PRODUCT INFORMATION NOTICE

1. TITLE	2. DOCUMENT NUMBER
MICROCIRCUIT, MEMORY,DIGITAL,CMOS, A X B-BIT, RADIATION-HARDENED SRAM MONOLITHIC SILICON	SPO-2018-PIN-0003
	3. DATE *(Year, Month, Date)*: 2018, Oct, 1
4. MANUFACTURER NAME AND ADDRESS: CAES, 4350 CENTENNIAL BOULEVARD, COLORADO SPRINGS, COLORADO 80907-3486	5. MANUFACTURER POINT OF CONTACT NAME: Peter Nelson
	6. MANUFACTURER POINT OF CONTACT TELEPHONE: 719-594-8238
	7. MANUFACTURER POINT OF CONTACT EMAIL: Peter.b.nelson@cobhamaes.com

Summary: This ADEPT adds two guaranteed by design AC timing specifications to both the datasheet and SMD (t_{AVSK} and t_{AVET2}) which where recommendations of the previously documented application note (AN-MEM-002). Datasheet changes are also noted herein. This change places the data from the app note into the datasheet and SMD to ensure that the user does not miss the timing info.

SRAM read cycle 1: address access.

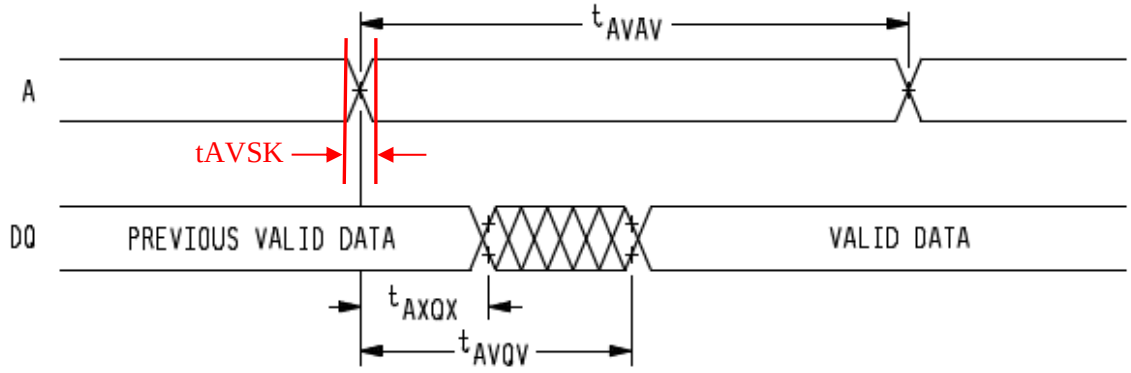
Add timing parameters to SRAM read cycle 1 and read cycle 2

Figure 4a. SRAM Read Cycle 1: Address Access

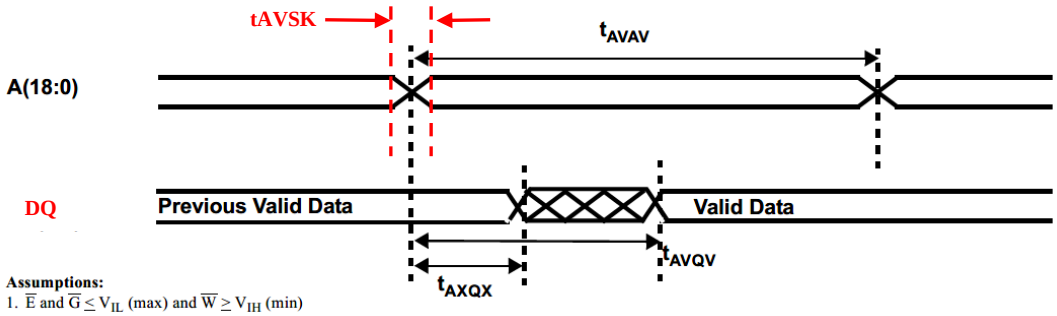
SRAM Read cycle 1 and 2
Adding parameters tAVSK and tAVET2 to timing diagrams
